IDYLLWILD WATER DISTRICT

Memo

Subject: Item 4 – Dudek Review Report pm 30% preliminary engineering from California Rual Water Association

Idyllwild Water District
Preliminary Engineering Report v. 2

Figure 4: Lift Station Pump Curve

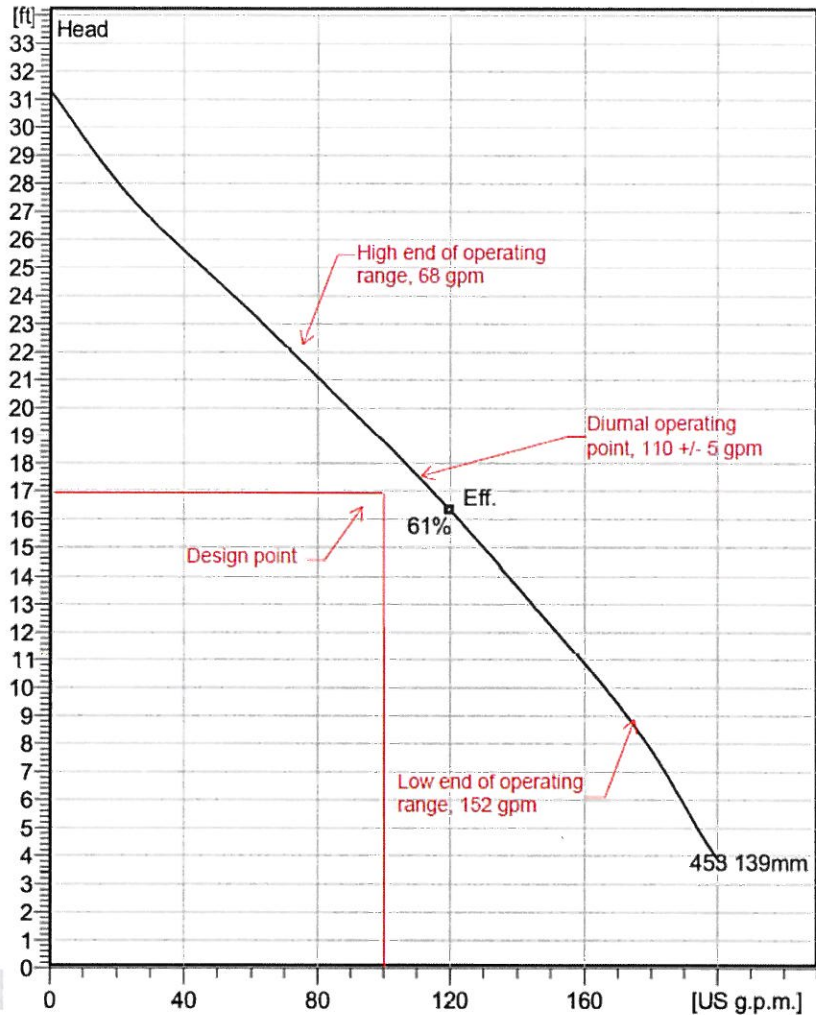
VFD can be a means of soft starting and slow stop of the pumps. Avoid surges. Lead/Lag operation eliminates a standby pump
